## Product Change Notification

**1. ECR #:** 221396  
**Notification #:** 671

**3. Series:**  
• 185 - 185 ST JACK FOR COMPRESSION MOUNT

**4. Part #'s Affected**  
• 185-J-P-EP-ST-CMM-X-X

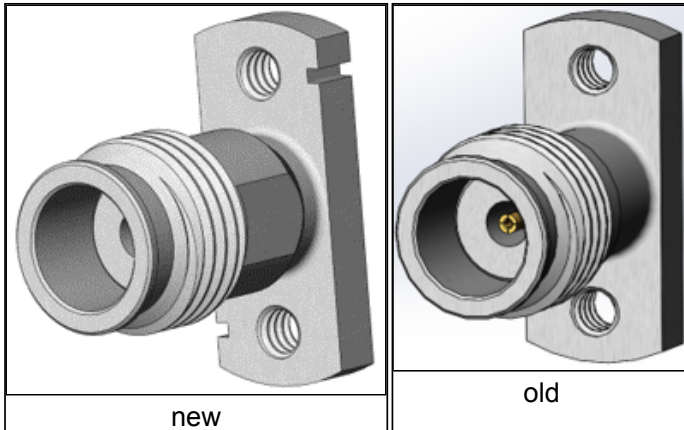
**5. Description of Change:**  
We added two grooves on our body for PCB mounting alignment and a flange for our custom wrench to prevent rotation.

**6. Method of Identifying Change**  
Two grooves and a flange on the new body

**7. Reason for Change:**  
For better alignment onto the PCB

**8. Impact of Change on Form, Fit, or Function:**  
• Form - Form change
